Point-by-point response to comments made by Reviewer #2

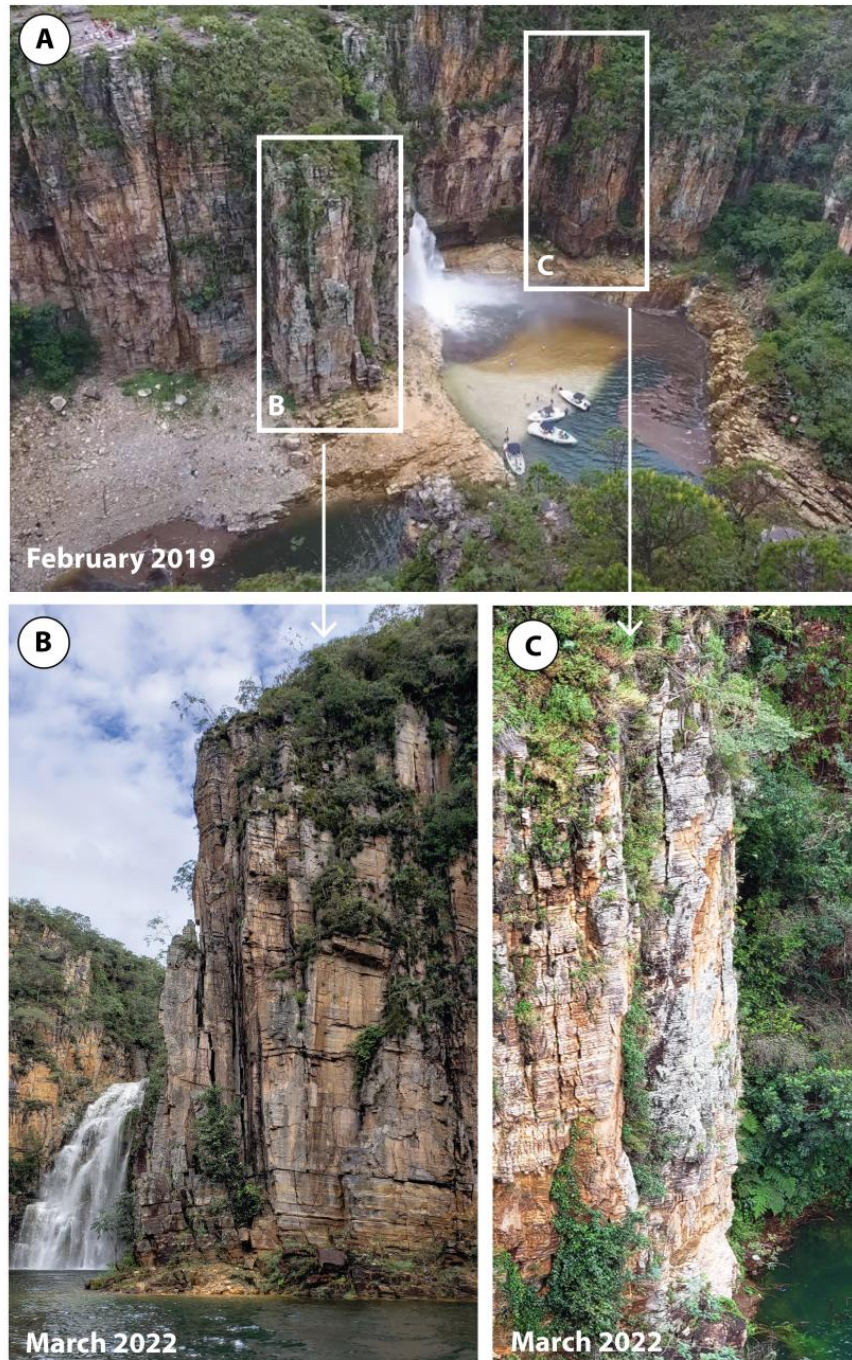
- 1. Readers would like to know if the kinematic criterion for toppling was met because toppling can be caused by the deformation of a weak base of a column, which progressively meets the conditions for toppling. A precise cross-section of the geology of the fallen column must be provided, including the locations of the discontinuities.*

In this context, we performed a stability analysis and a more detailed kinematic evaluation in a portion of the Capitólio canyon that is interpreted to have a similar context to the location where the rock-toppling event occurred. While this portion did not fail on January 8, 2022, the variations in the FoS can support our analysis of the conditions that potentially led to the fatal event.

The stability analysis is based on the combination of FEM and LEM methods, to support the investigation of the effect that some previously inferred mechanisms had on rock instability, such as rainfall infiltration and reservoir water-level fluctuations. The FEM analysis evaluated the effect of reservoir water-level fluctuations and rainfall infiltration on the rock mass, with the results (pore pressure) being imported in our LEM analysis of the slope stability.

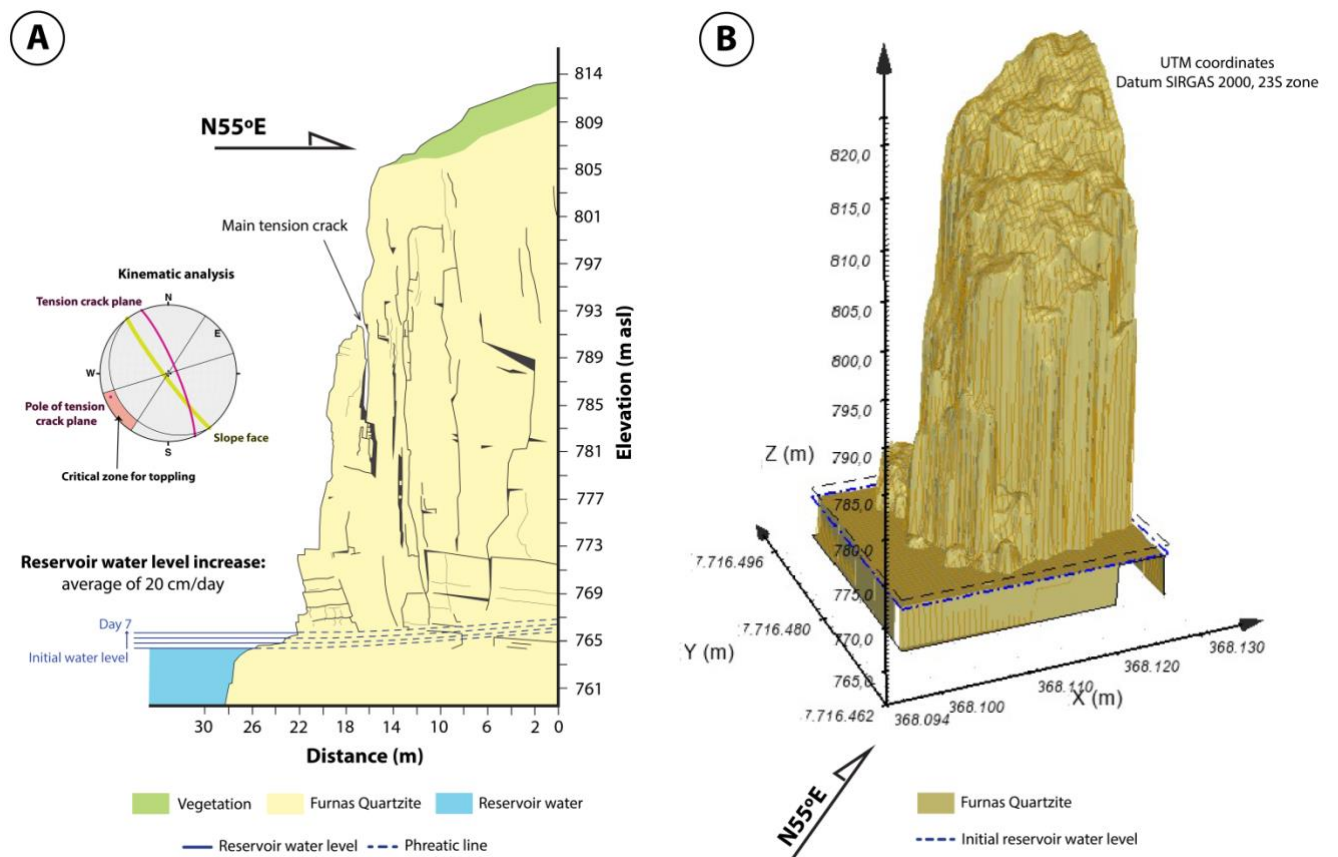
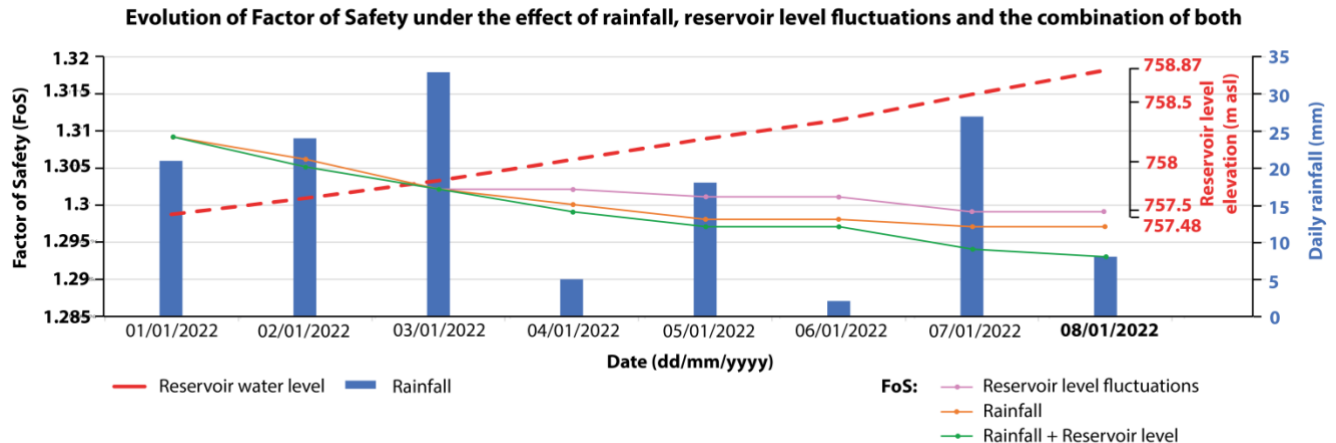
3. *The increase in water pressure is also questionable because no exceptional precipitation and a relatively low reservoir level were measured during the event. These conditions can be considered triggers for failure in highly fractured rock, but this must be argued.*

When only water-level fluctuations were considered, the numerical results show that it impacted slightly the FoS of the slope, decreasing from 1.309 to 1.299 in the eight-day period (**Figure 14 and Table 11**). The impact of rainfall on the FoS was slightly higher, decreasing to 1.297 from 1.309 in the considered timeline. The combined effect of rainfall and reservoir water-level fluctuation impacted the FoS the most, decreasing from 1.309 to 1.293. While these scenarios were not sufficient to cause a slope failure at this location, it can suggest how these different factors impacted the site that did fail on January 2022. Thus, based on this relationship between FoS, water-level variations and precipitation, it can be suggested that both rainfall and reservoir water level had a role on the rock-toppling initiation, with rainfall infiltration with a slightly stronger influence on slope stability.

We appreciate the suggestion. As discussed previously in this document, we have included a stability analysis based on the combination of FEM and LEM, which supported the evaluation of the effect that some previously inferred mechanisms had on rock instability. The impact of the reservoir water level was not expressive, as highlights the FoS, but it is interpreted to have contributed to the slope failure. Rainfall, however, is suggested as having a more significant role in rock instabilities in the canyon.

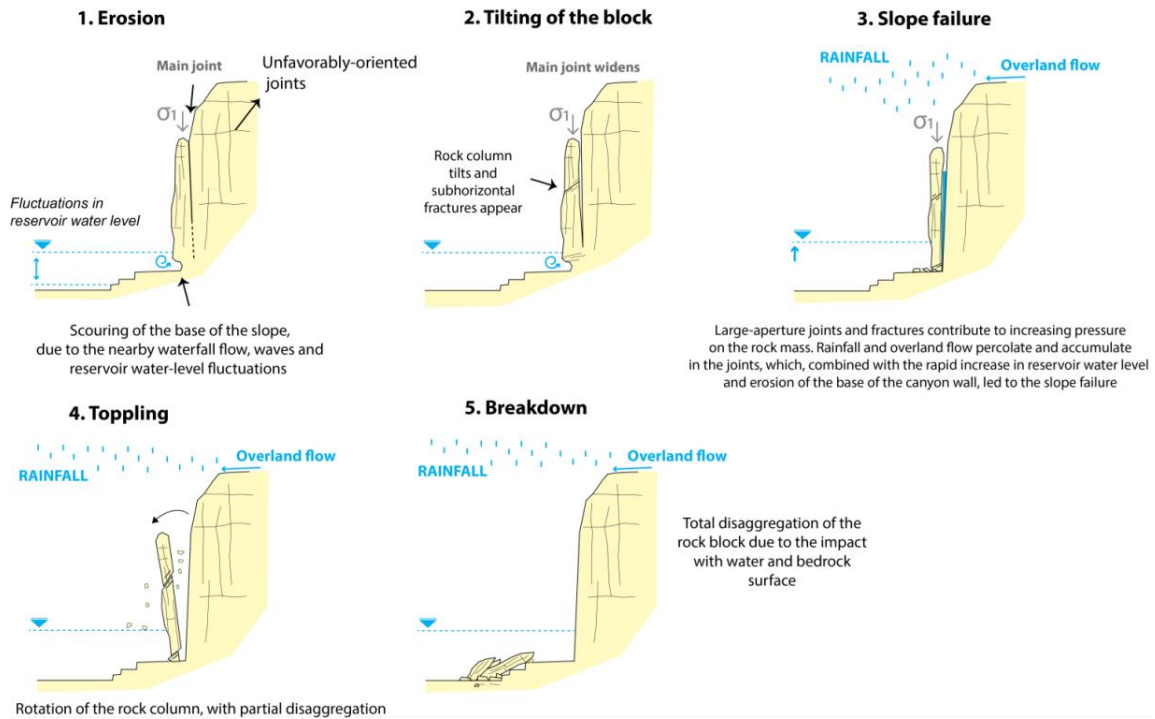
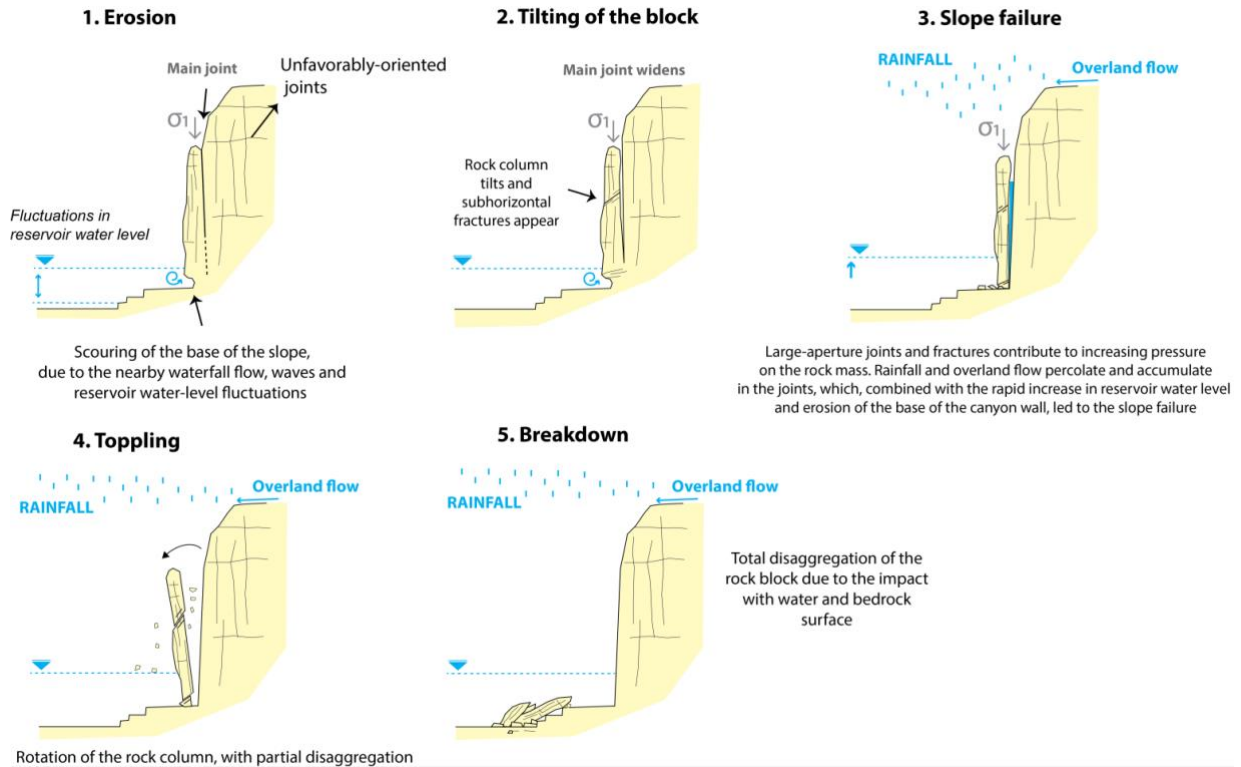
15. Figure 6: As shown, the rainfall cannot fill the back joint. There must be a way to bring water there: overland flow or the water table level.

We have reviewed the figure, to include overland flow accumulation, which is interpreted to potentially have also contributed to water infiltration in the joint system of the bedrock. The revised figure, which is now Figure 16, is presented below:

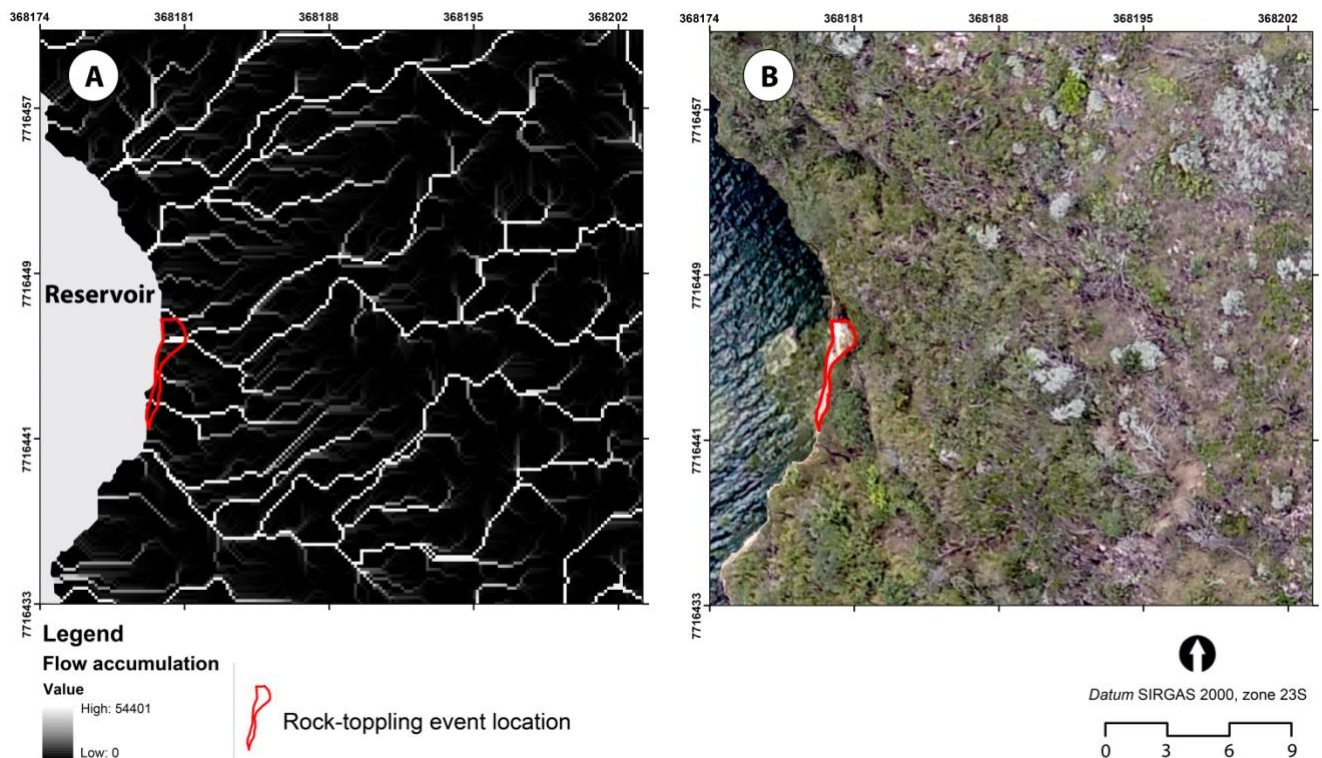
4. *Additionally, the topography of the upper part of the cliff must be detailed, as it can concentrate water through overland flow, which can then enter the rock cliff.*

Thanks for the suggestion and we have included an overland flow accumulation map, based on the digital surface model (DSM) of the region at the top of the Capitólio canyon. The map highlights how the overland flow accumulates at the site of the 2022 disaster, which can contribute to the water infiltration in the joint system of the bedrock, as well as intensify the long-term erosion/weathering on this location.

“Furthermore, overland flow accumulation in the site of the rock-toppling event (**Figure 12**) can also contribute to increasing the water content in the fracture and joint system, adding more pressure on rock column that ultimately toppled. The overland flow pathways in the region right at the top of the rock-toppling event concentrate in the area that failed, which, besides increase water accumulation in the joints, can also intensify the erosion and increase the susceptibility of this area to rock instabilities.

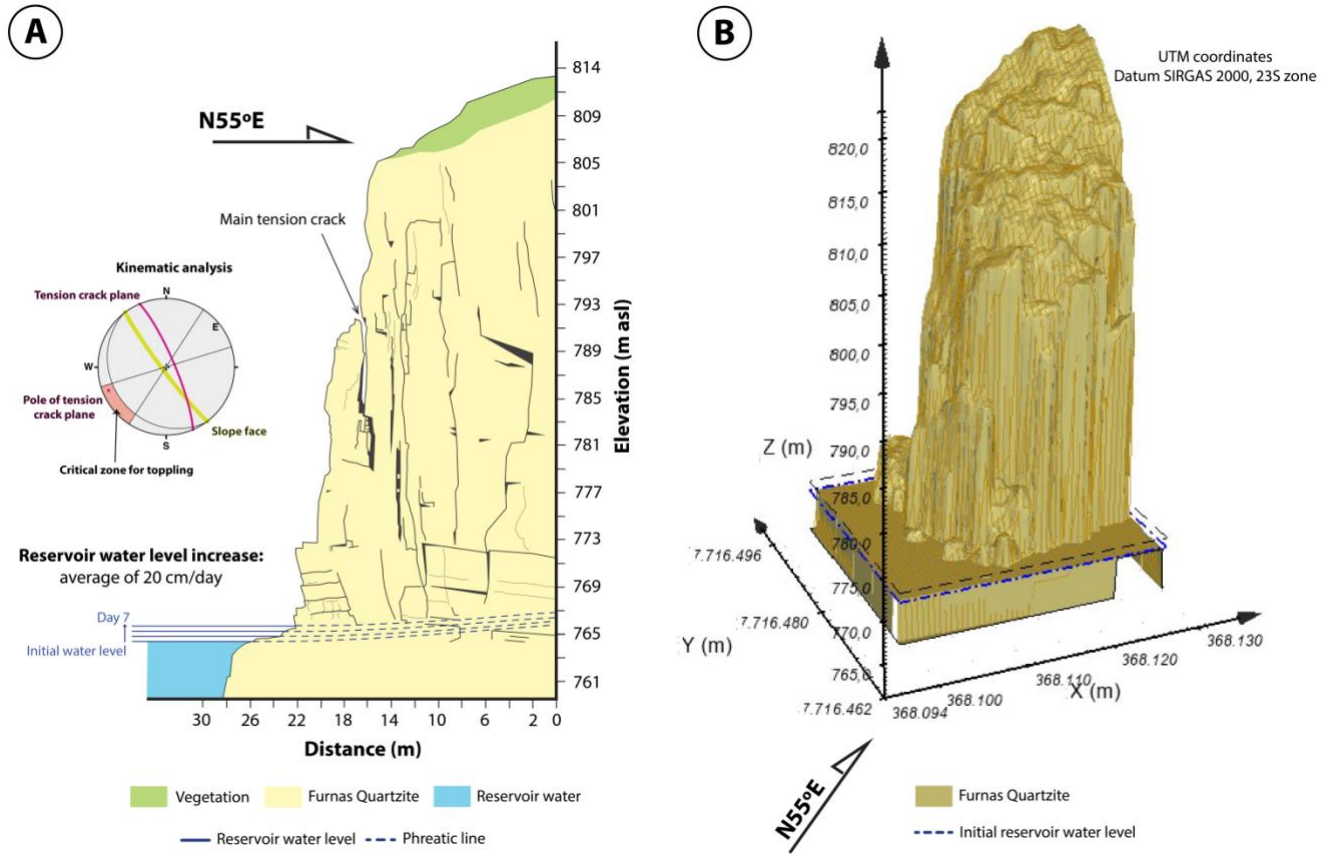
5. *A real 3D model of the column and structure must be presented to fully understand the mode of failure, which is important for further analysis. The volume of this column has not even been estimated.*

7. *Additionally, why are overhangs not explicitly studied as seen in Figure 13b?*

As highlighted previously, we did not have access to high-resolution pre-event elevation data for the site that the rock-toppling event occurred. To overcome this deficiency, we have focused our analysis in a site that is interpreted as having a similar geotechnical-geological condition as the one that the slope failure occurred. The main difference between these sites is the lack of cavities at the bottom of the slope, resulted from erosion. These cavities are interpreted as an important predisposing condition for the slope failure, contributing to the loss of underlying support of the rock mass. This is argued in the new version of the manuscript.

The stability analysis, as well as the updated kinematic analysis, is based on the 3D model that was acquired using UAV (Figure 13 below):

We chose not to include overhangs in the current research as it would expand the main focus of our analysis, as well as since it is not the type of slope failure that led to the disaster. We have adjusted the manuscript to focus only on areas where rock-toppling is the main geodynamic process.

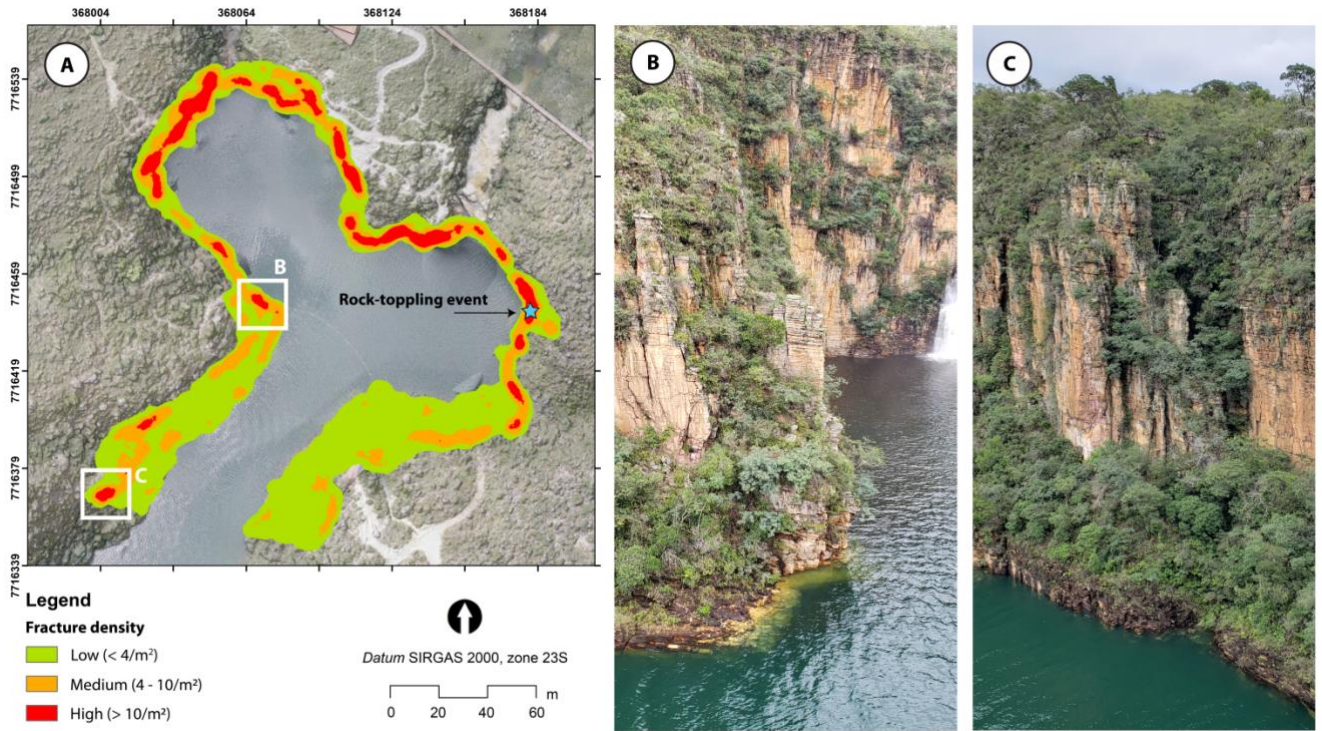
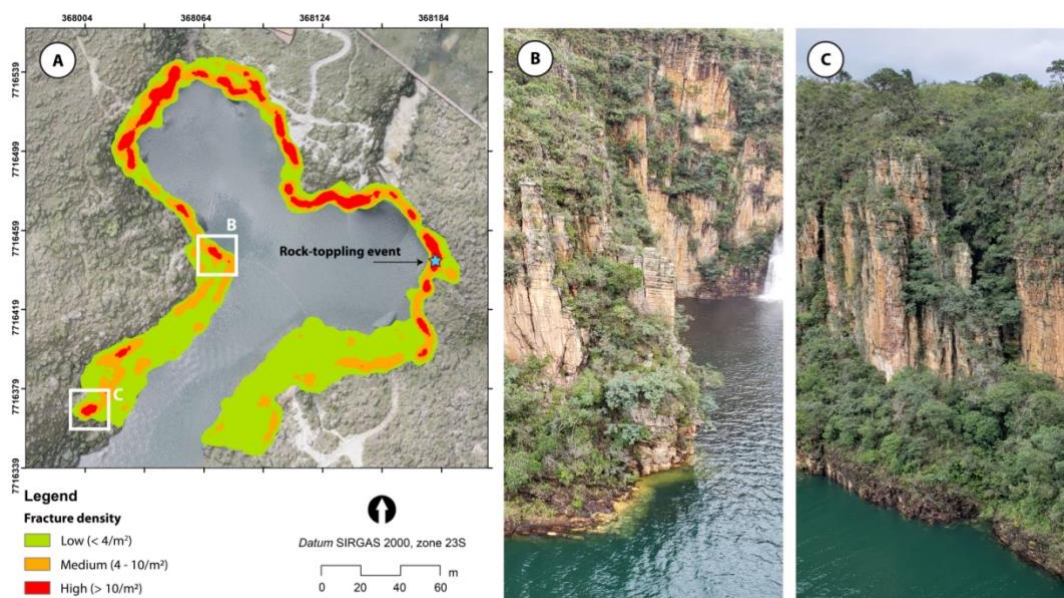
21. Lines 401 and 413: How are these movements detected?

22. Line 402: This invalidates the approach of the average steronet slope orientation.

We have altered the sentence and included the information about the joint density map, highlighting how these slope movements are detected:

“The fracture density map shown in **Figure 7** further highlights that in the portions that discontinuities/fractures show a higher density per square meter, the susceptibility to rock instabilities is apparently higher, with tilting rock columns observed in these areas (**Figure 7B and 7C**), indicating movements in the rock slope. Larger apertures in the joints, especially at the top portion of these rock columns, are also observed, which are another indication of slope movement. The intersection of joint sets with perpendicular strikes favors the formation of these individual rock columns, which, combined with the horizontally dipping bedding, contribute to rock instabilities in the canyons.”
